# REGIONAL REVIEW FINDING

**ARC REVIEW CODE:** R1805172

**Name of Proposal:** Echo Street (DRI 2814)

**ECHO STREET MIXED-USE DRI #2814**  
**City of Atlanta**  
**ARC Natural Resources Group Review Comments**

TITLE: DRI SITE PLAN

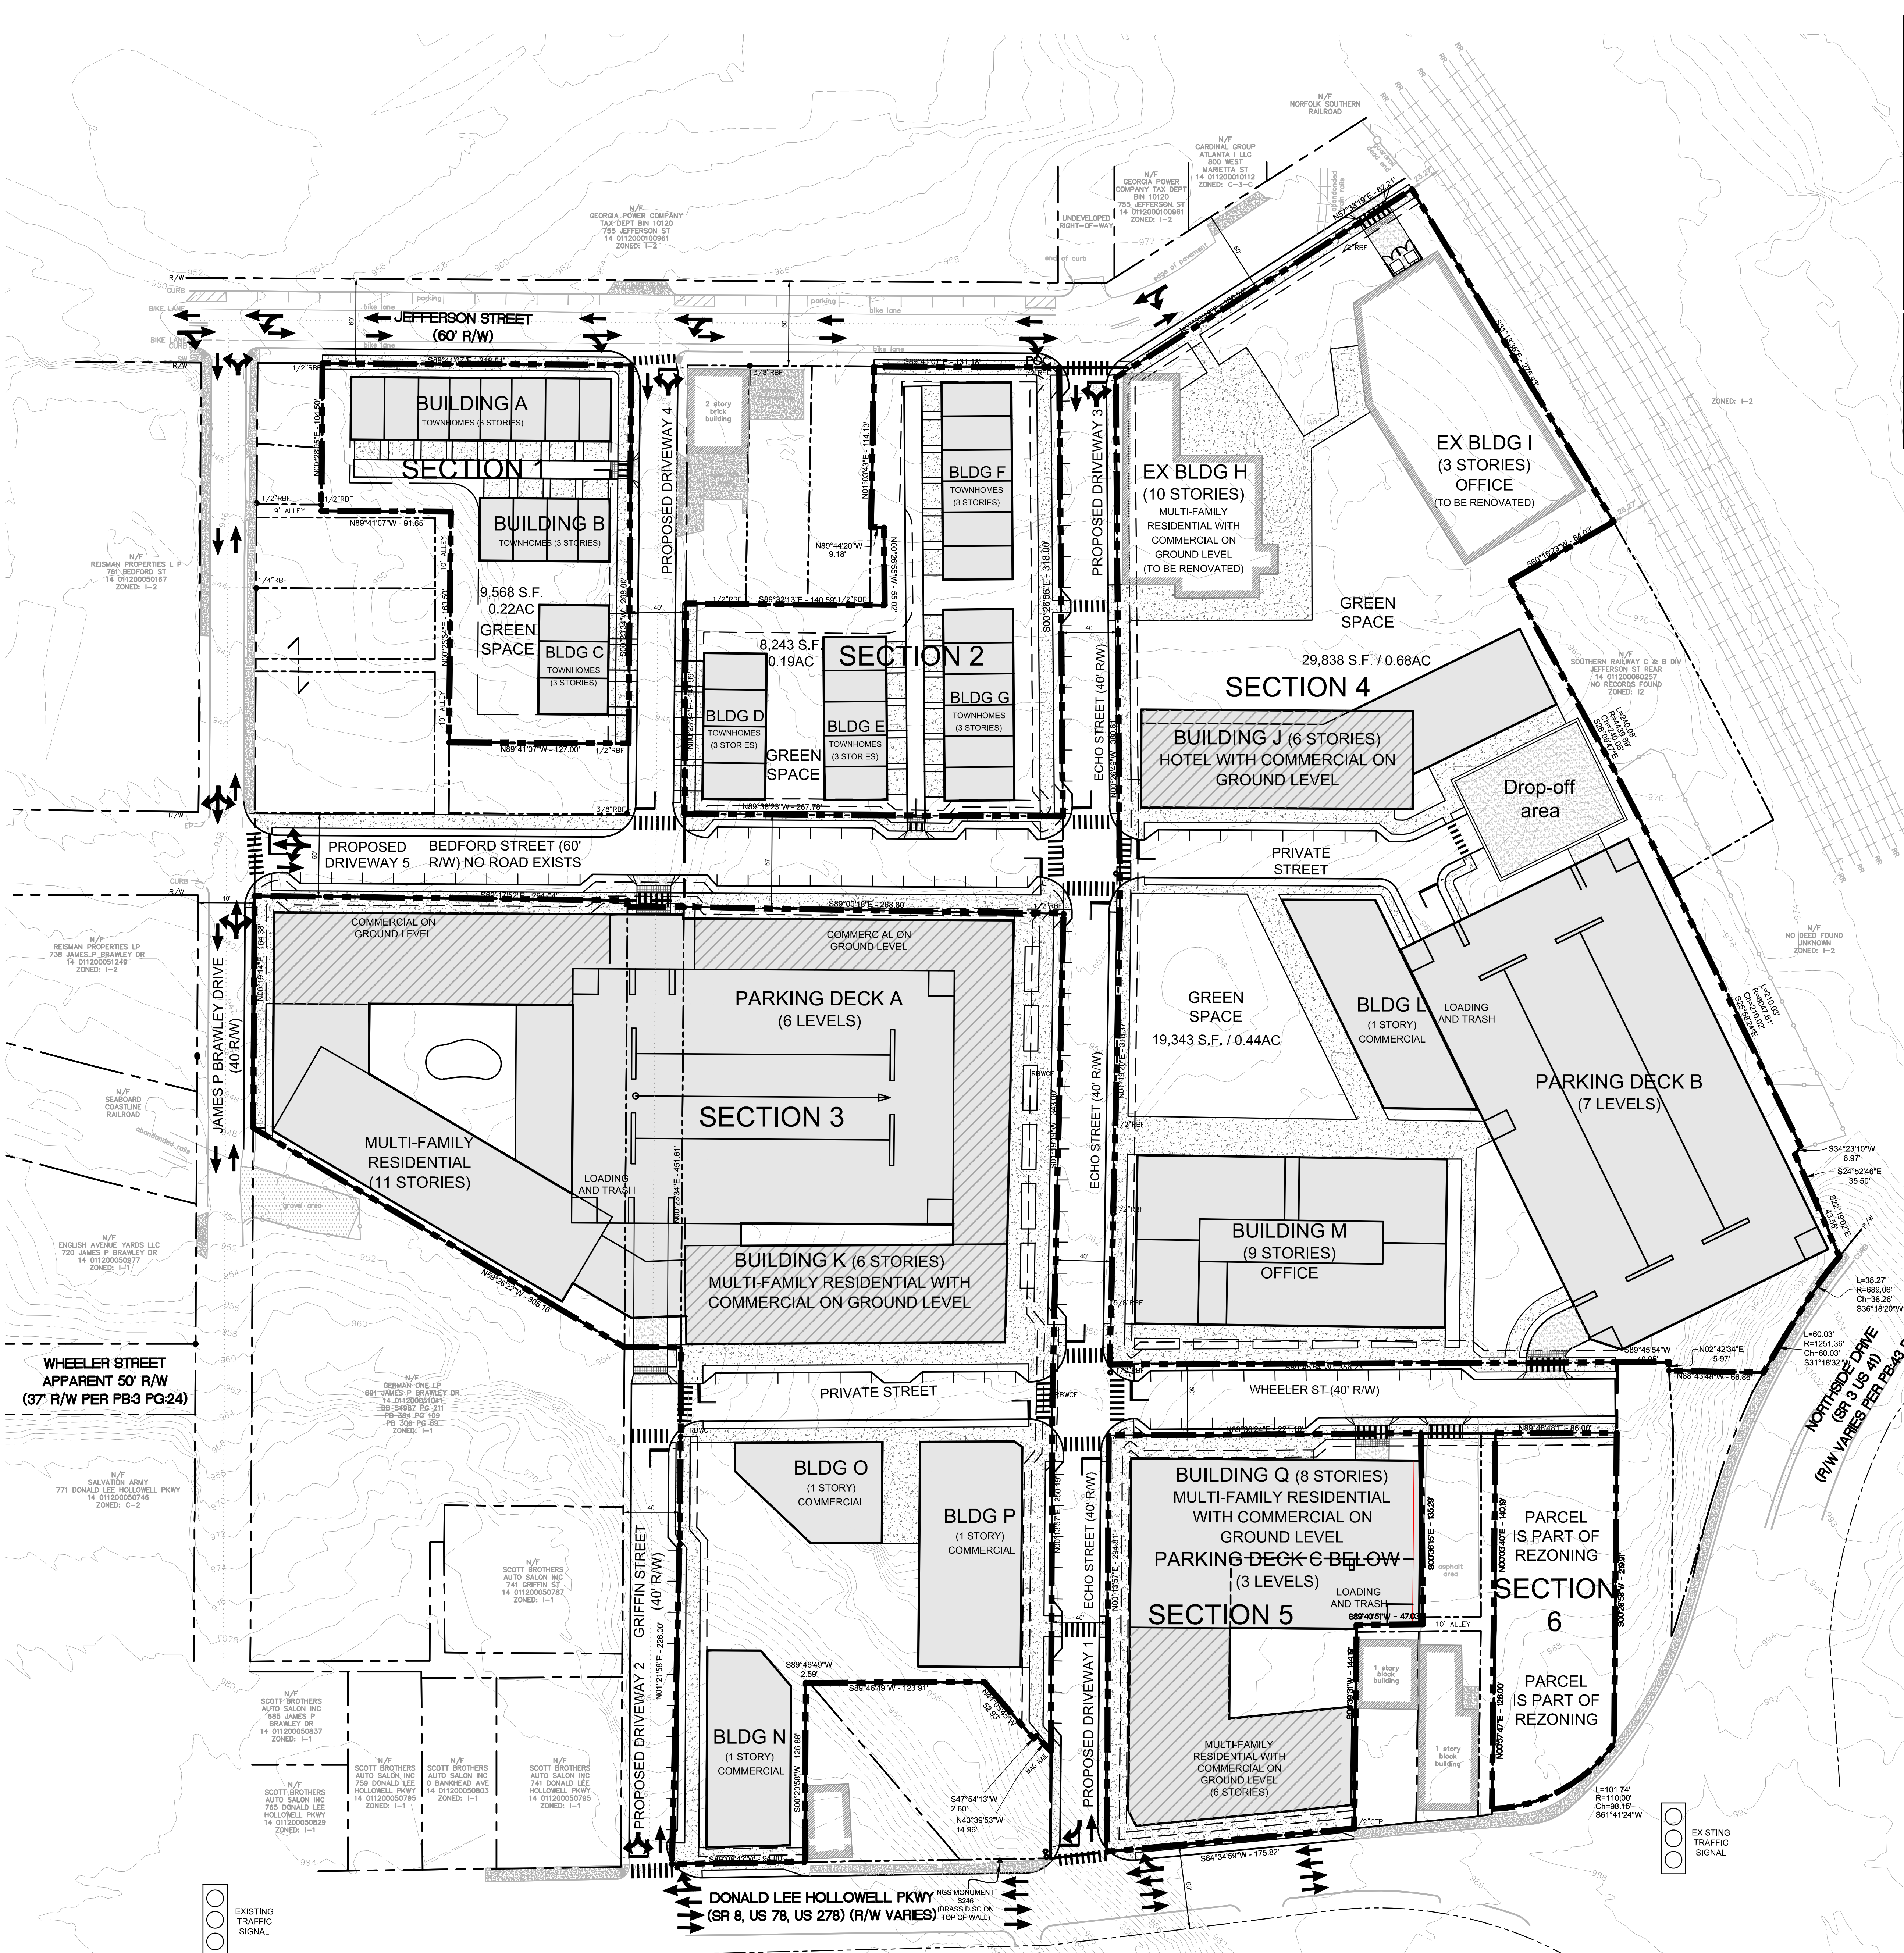
### Site Plan Comments...

It would be appropriate to see a ped/bike crossing of the Western Trunk along Jefferson Street, to align with Hampton Street to access PATH Parkway. (Yes this would require private property crossings on the Marietta Street side.) DRI site development should not preclude this in 3 dimensions, if it is not outright responsible for participating in constructing it.

Variances to MRC3 streetscape requirements would be appropriate for much of the internal site, but the public ROWs should remain or be made public.

The uber-vast majority of the multi-family market in ATL is building stick-framed 5-story stuff, maybe on a concrete podium. This DRI proposal seems to NOT be catering to this market with 6-8 story residential, which for the location is a bit odd....

Project does NOT address Northside Drive at all. This segment of Northside Drive is inhumane right now and with the current design, seemingly remains so. How is the parking deck screened? MRC3 would require that the streets be made much more ped-friendly, no?

Work with ABI in 3 dimensions to access a future trail

If DLHP is desired to be a 4-lane, there needs to be ROW allocated for wider lanes AND wider sidewalks
